NOTICE OF MEETING

The City of Lake Elmo

TO: Planning Commission
FROM: Emily Becker, City Planner
AGENDA ITEM: Lakewood Crossing 2nd Addition General Planned Unit Development Concept Plan
REVIEWED BY: Stephen Wensman, Planning Director

Re: Lakewood Crossing 2nd Addition
Concept Plan Review

A2.1

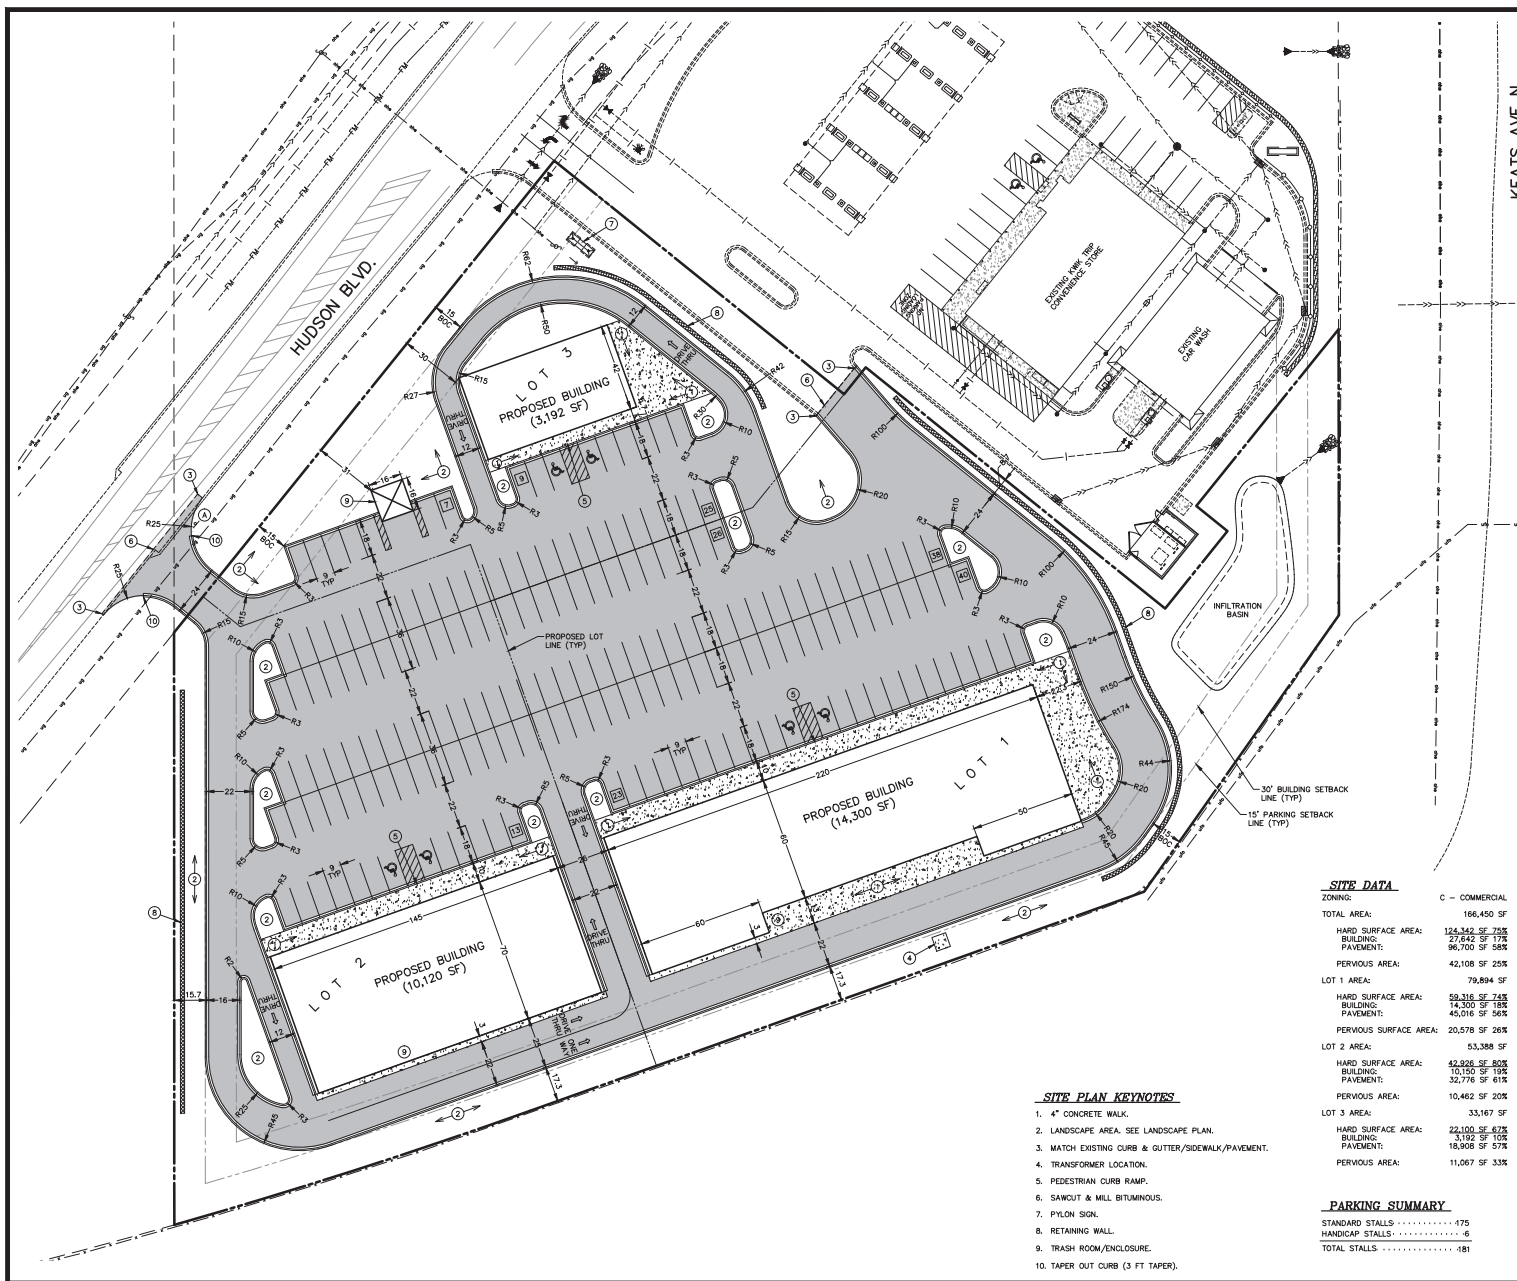
- *Orientation of buildings.* The unique shape of the parcel that is being developed resulted in a unique shape of Lot 3. As a result, the building is oriented according to the shape of the parcel and to accommodate better traffic circulation and proximity to the parking lot.
- *Landscaped open or gathering spaces.* Being that this a small commercial development located in close proximity to the highway that will likely serve quick visits, Staff does not feel it necessary to provide this open space. An outdoor dining area is being proposed, and the restaurants will likely provide adequate seating for guests.

- *Sidewalks.* No sidewalk is provided along Hudson Blvd. However, there are no other sidewalks along Hudson Blvd. to which it could connect. There is an on-road bike lane on Hudson Blvd that will accommodate bikers.
- *Streetscape Lighting.* No lighting is provided along Hudson Blvd. Lighting is provided within the interior of the parking lot.
- *Fencing of Outdoor Dining Areas.* The applicant has not indicated on the site plan where the outdoor dining plan will be located.
- *Site furnishings.* The Commission may wish to recommend that the applicant include these in the site plan.
- *Parking.* The plan provides minimal exterior parking lot landscaping and screening. Additionally, the parking lot is located in the front of two of the buildings and exceeds 60% of the street frontage.

<i>Site Furnishings</i>	Such as decorative fencing, trash receptacles, planters, bicycle racks, and benches are recommended – design elements from Branding & Theming Study encouraged.	The applicant has not included these items in the site plan.
<i>Parking</i>	Linear measurement of surface parking areas parallel to the public street are encouraged to not exceed more than 60% of primary street frontages. If this cannot be met, berms and/or additional landscaping along areas of surface	Surface parking exceeds 60% of the primary street frontage, and there is minimal landscaping proposed.
